ADDENDUM NO. 3

DOLPHIN PIER REPLACEMENT CITY Marina at GARRISON BIGHT ITB#17-015

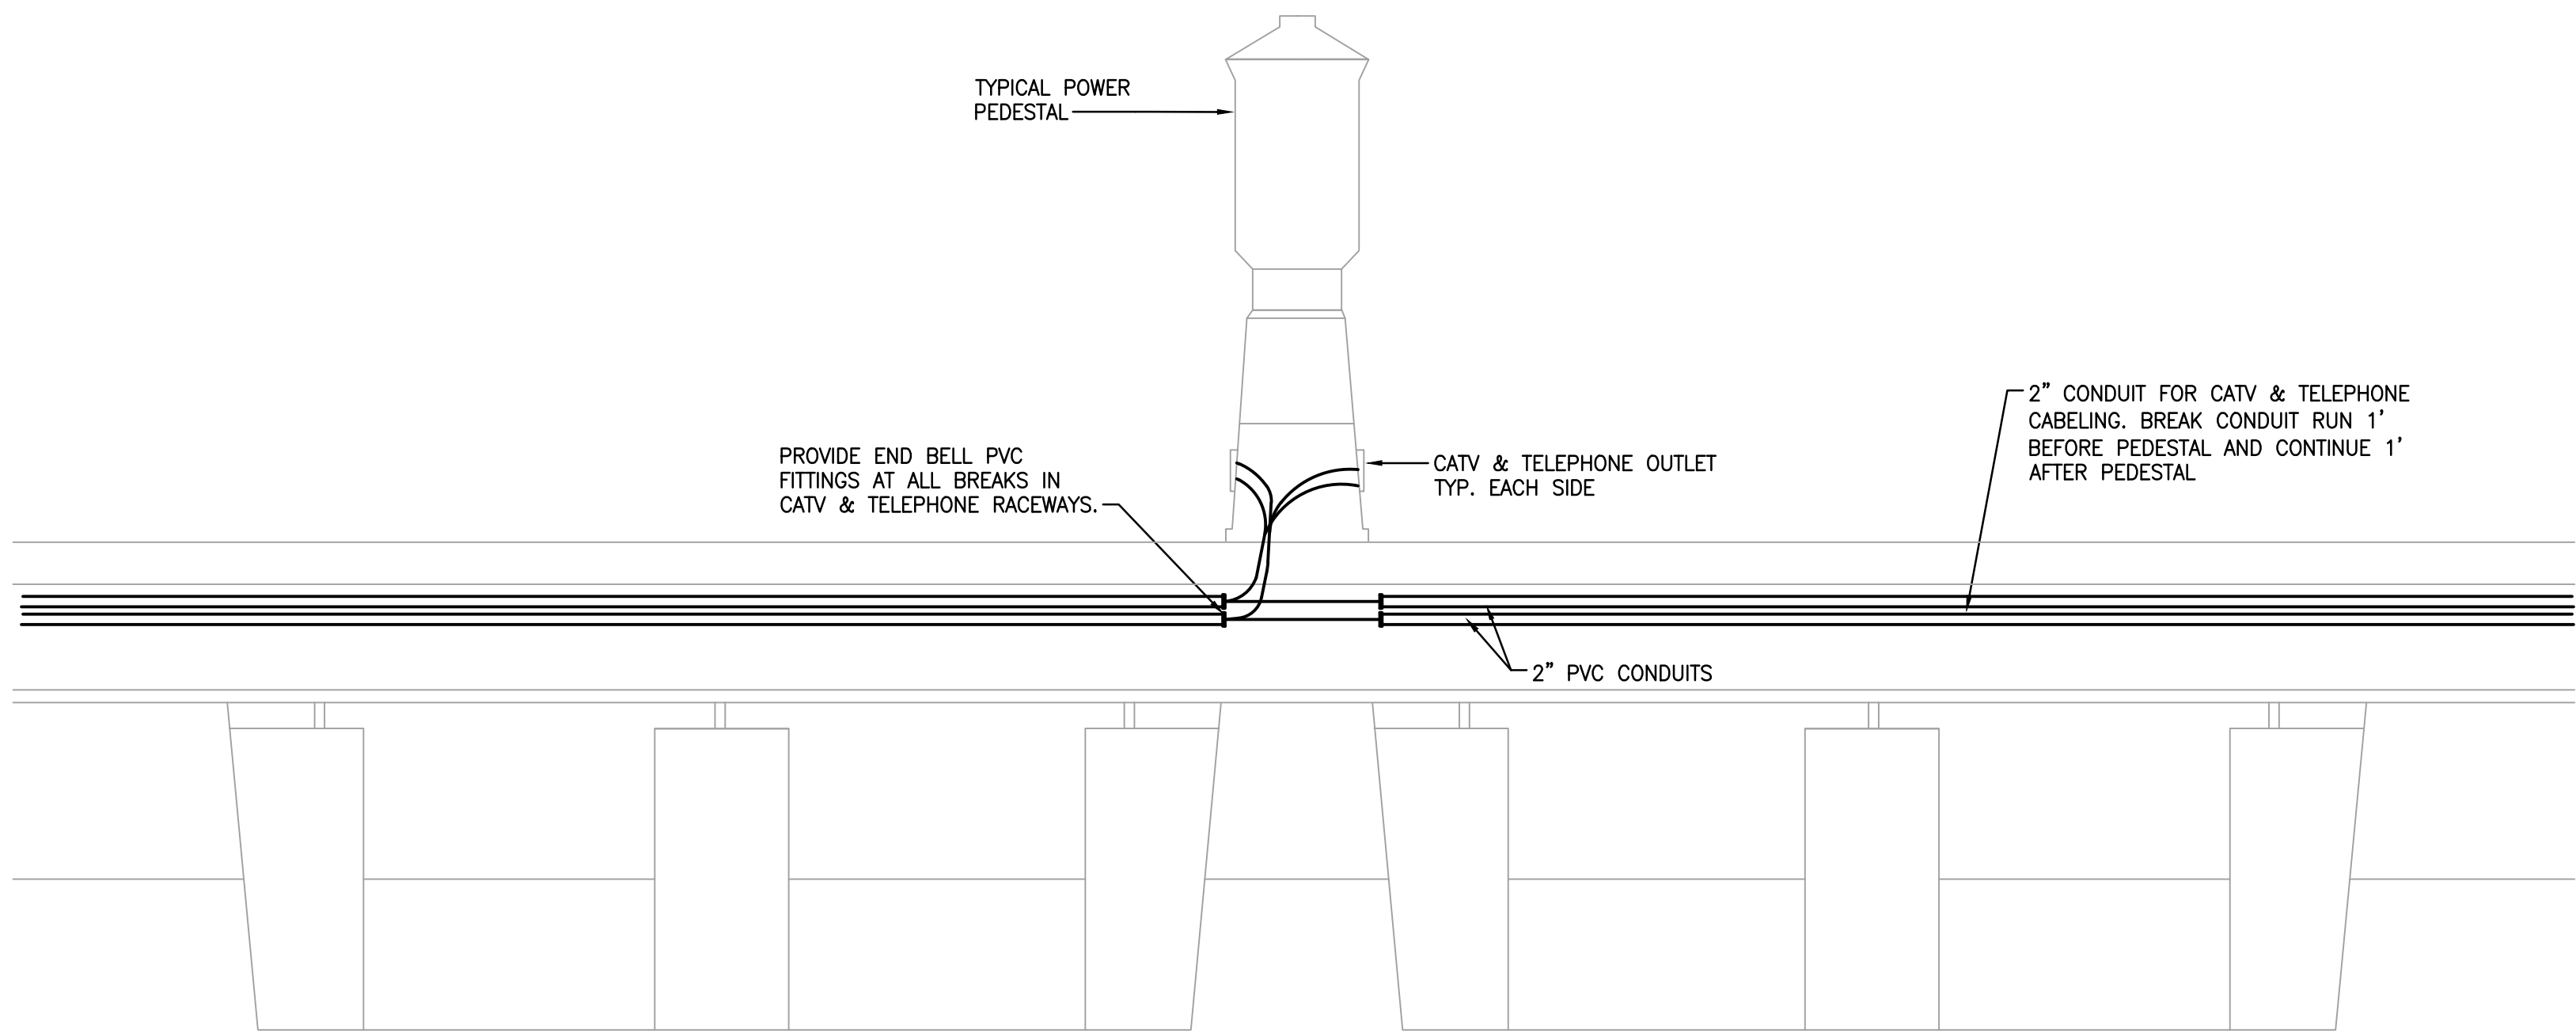
13. The dock specifications indicate dual top-access utility troughs, 6" deep x 12" wide. The drawings show a stainless-steel utility tray running under the docks. Are either of these required, or is it acceptable to have ample space under the decking to facilitate all the utilities?

R. Contractor to use Stainless-steel utility tray running under the docks.

<u>Page(s)</u>	<u>Description</u>
00 21 13-1	"Instruction to Bidders" Has been revised to "8 Calendar Days Prior to Bid Opening".
Technical Specifications	TS-4.0 Section TS-4.1 has been revised: <ul style="list-style-type: none">• Chases Stainless-steel utility tray

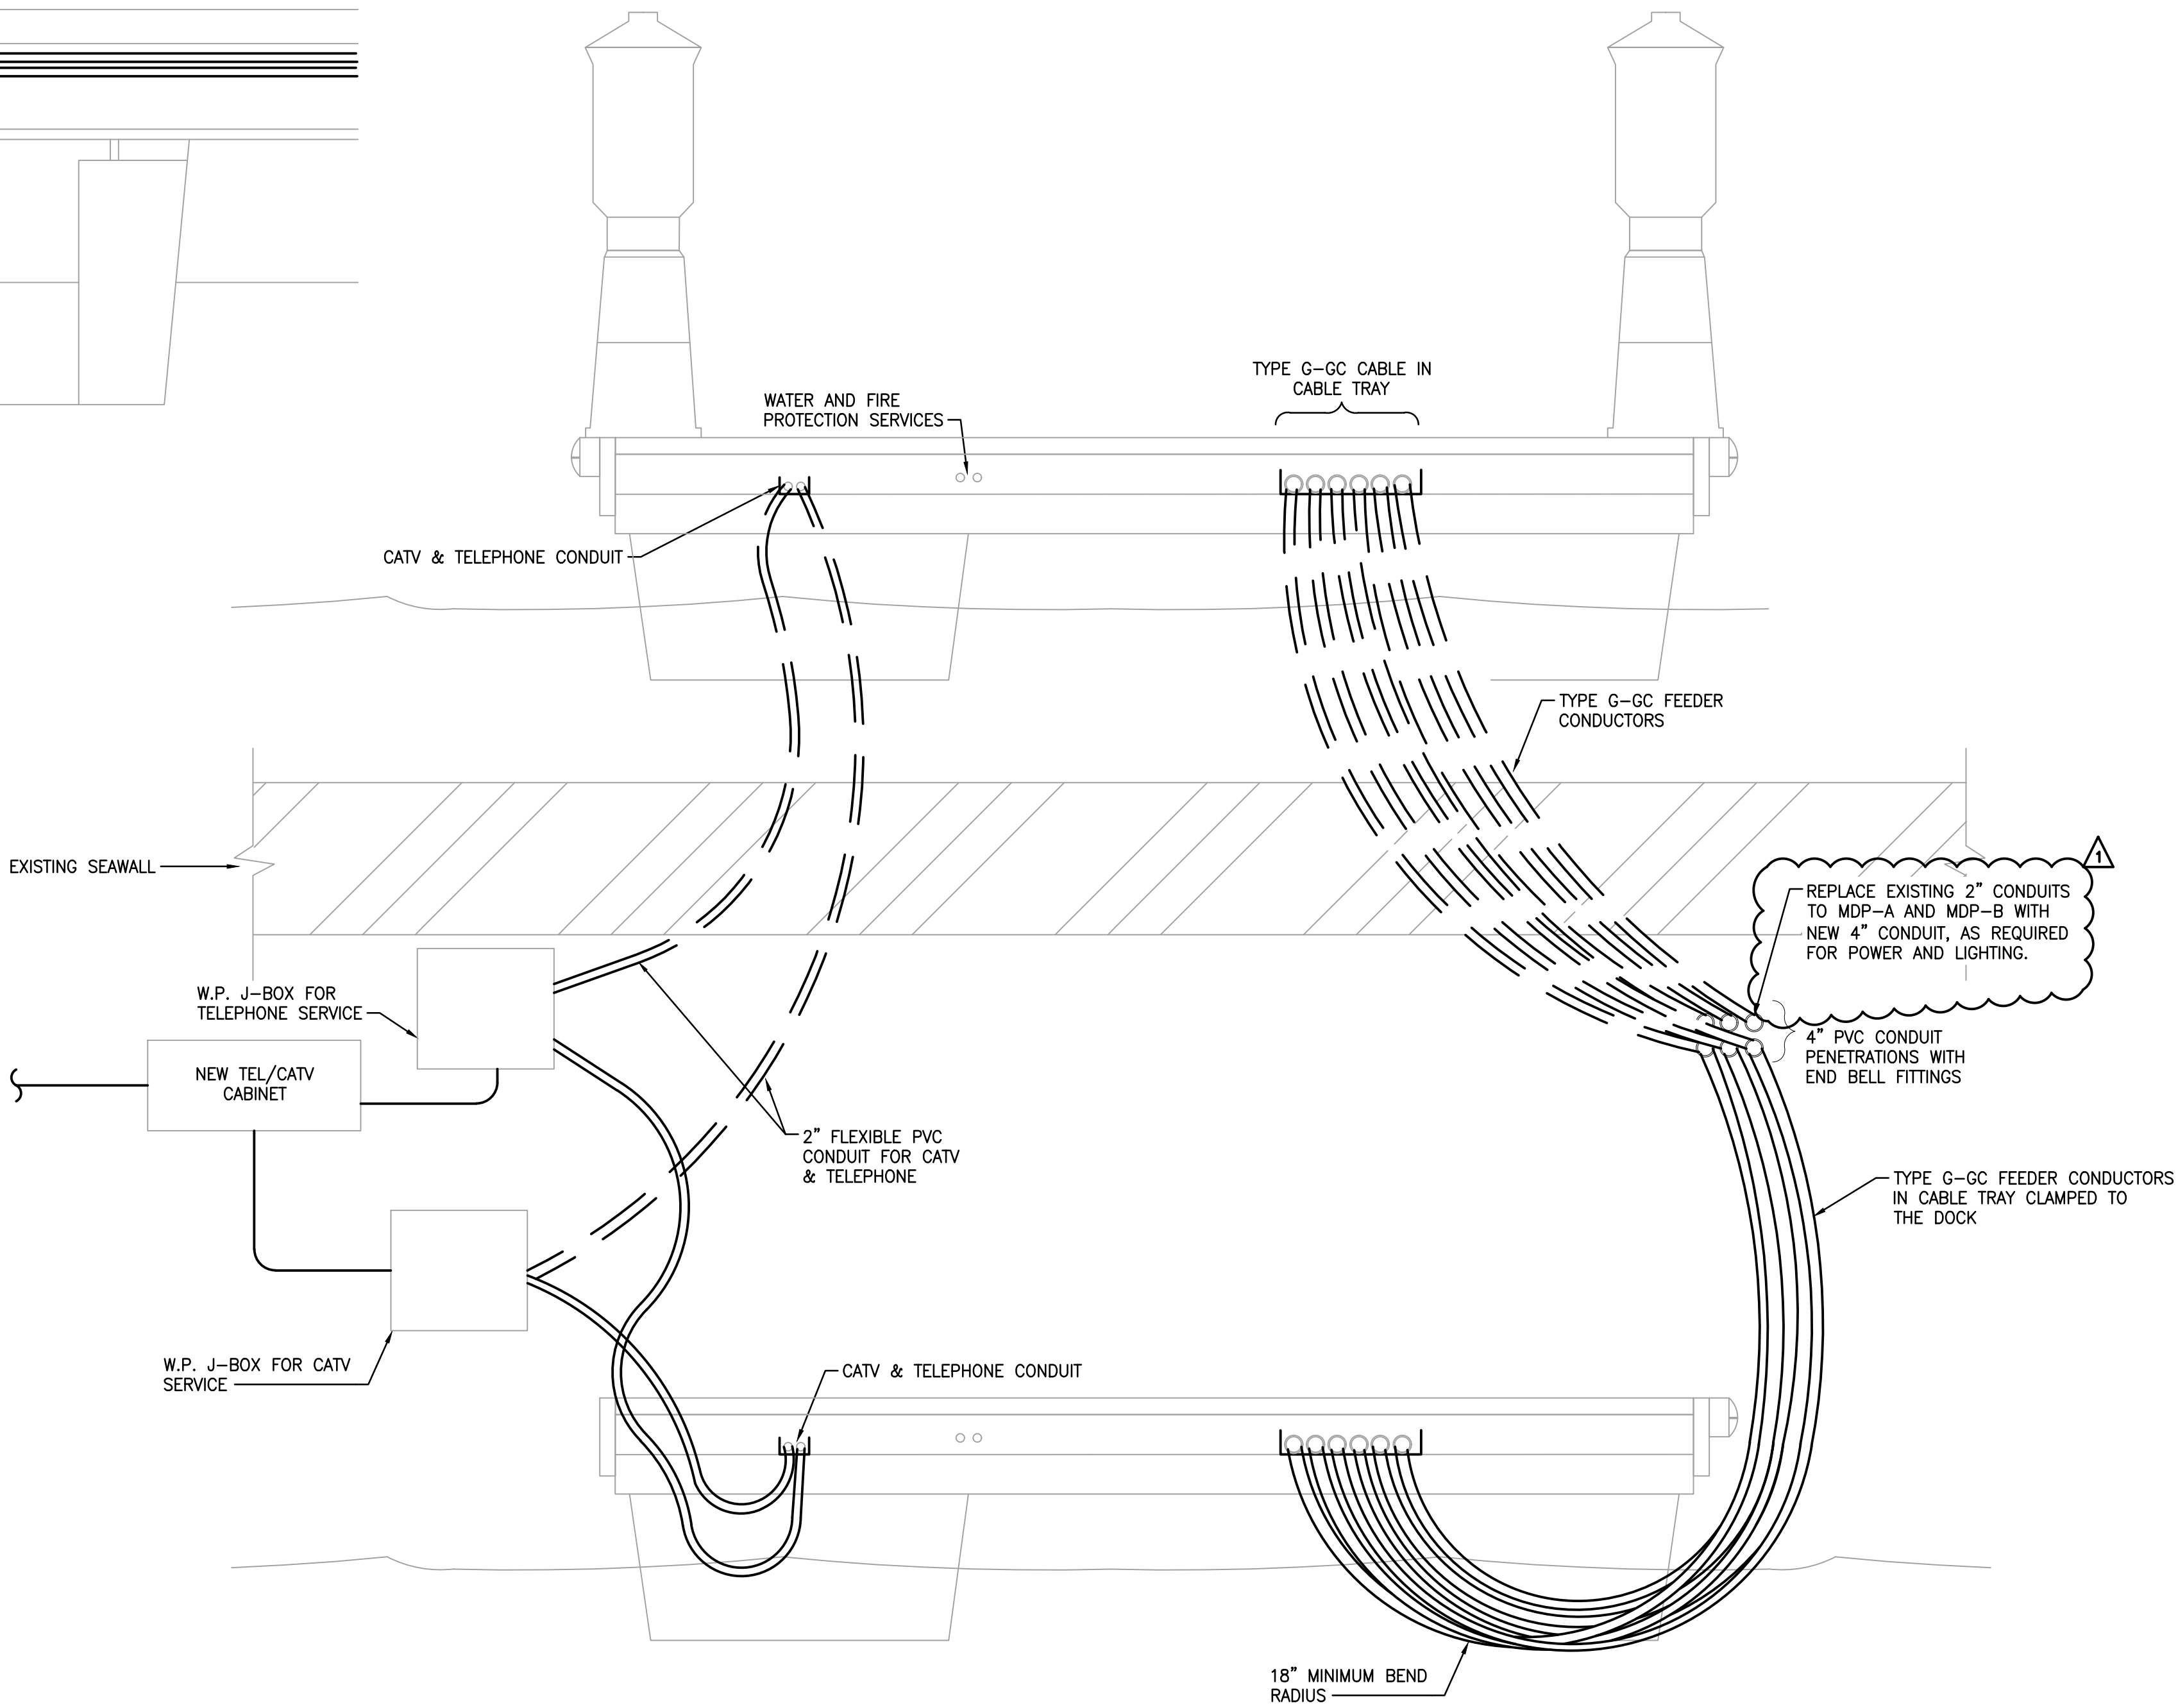
2. Observed on-site that the existing conduit was too small (2"). The required size is (4"). Are we to remove existing gear and platform to accommodate appropriate size conduit?

9. Is the existing concrete vault to be reused or a new vault or stand to be installed?

11. Are the existing conduits feeding the pier of sufficient quantity, and size to accommodate the new G-GC cable outlined in the feeder schedule?

R. The size and quantities of conduit will need to be modified to accommodate the new G-GC cables. See revised sheet E06.

R. Existing vault may be reused – however the existing 2-inch conduits are inadequate for G-GC cable and will need to be replaced, as shown on plans. See revised sheet E06.

R. No – the conduits will need to be replaced with larger size and quantity. See revised sheet E06.
